Subject: Response to letter dated June 30, 2010, Open Issues, License Amendment, Crow Butte Resources, Inc., Crawford Nebraska, License SUA-1534 (TAC J00555)

Responses to NRC Open Issues, License Renewal Amendment Request, Crow Butte Resources, Inc., Crawford Nebraska, License SUA-1534 (TAC J00555), dated June 30, 2010

Figure 1: Dissolution of Crow Butte Samples

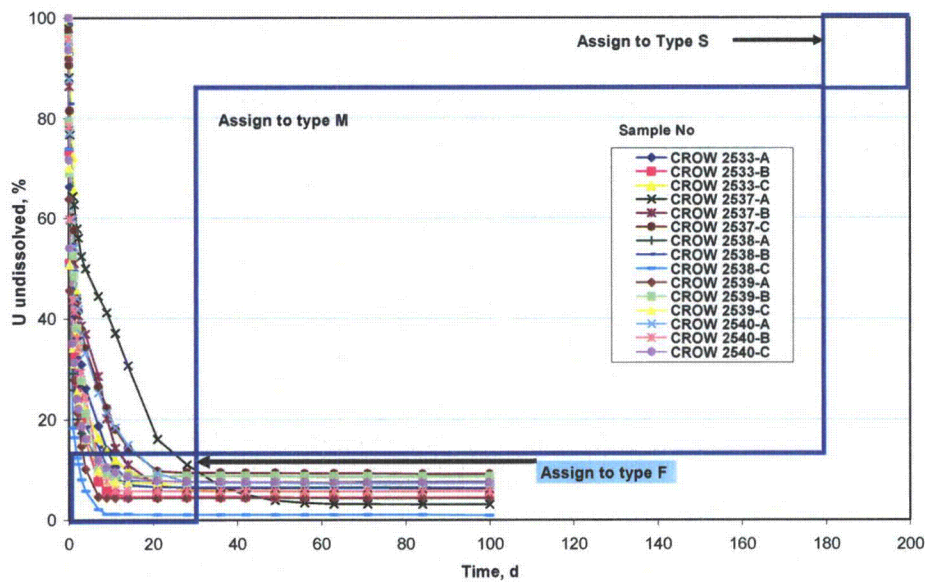
<p>C. Section 5.8.3.1, Airborne Uranium Particulate Monitoring</p> <p>1. In CBR's May 12, 2009 letter (ML091470119) responding to NRC staff's Request for Additional Information (ML083660060), it did not provide sufficient information to justify the use of 100 percent Class D yellowcake. Please provide technical justification for assuming 100 percent Class D inhalation class for the yellowcake produced at the Crow Butte Project. In addition, if the proposed inhalation class changes, provide an appropriate revised lower limit of detection for measuring uranium in air.</p> <p><i>Response: As a standard, the NRC has traditionally used Class D solubility for natural uranium as the inhalation class when approving ISL license applications and renewals and when performing compliance inspections. That approach is consistent with Reg. Guide 8.30, where NRC stated:</i></p> <p><i>"Yellowcake dried at low temperature, which is predominantly composed of ammonium diuranate, or in the new processes uranyl peroxide, both are more soluble in body fluids than yellowcake dried at higher temperature; and a relatively large fraction is rapidly transferred to kidney tissues (Refs. 9 to 11). If the intake of such yellowcake is controlled to protect the kidney from the chemical toxicity of uranium, radiological protection criteria for natural uranium will also be satisfied. For purposes of compliance with 10 CFR Part 20, yellowcake undried or dried at low temperature should be classified as soluble.</i></p> <p><i>Yellowcake dried at high temperature is a mixture of compounds that contains a major portion of more insoluble uranium oxides. Radiation dose to the lung and other organs is the limiting consideration rather than chemical toxicity; this is primarily due to the large insoluble component. For compliance purposes, yellowcake dried at 400°C (752°F) and above should be classified as insoluble (Refs. 12 and 13)."</i></p> <p><i>Cameco is unaware of any data which contradicts or undermines this long-standing conclusion which was based upon a substantial body of scientific literature. The uranyl peroxide yellowcake produced at Crow Butte is dried with a dryer oil temperature of approximately 230°C. During inspections at Crow Butte, NRC has repeatedly evaluated both the historic results of the exposure program and the appropriateness of the selected DAC, and has confirmed the adequacy of the bioassay program. As such, the current solubility classification remains valid and a revised lower limit of detection for measuring uranium in air is not required.</i></p>

Figures 1 and 2 present the dissolution curves (% undissolved as a function of time) for the Crow Butte and Smith Ranch samples respectively, aligned with the ICRP 71 F/M/S classification system (see ICRP 71 Appendix D).

It is clear that yellowcake produced at Crow Butte is quite soluble and should be assigned as 100% Class D for purposes of the 10 CFR 20, Appendix B, Table 1 DAC for natural uranium. Despite the <10% Class W component, the yellowcake is considered soluble and meets the definition of "low fired yellowcake". The definition of "low fired yellowcake" used in Regulatory Guide 8.22 is defined in NUREG 0874 as:
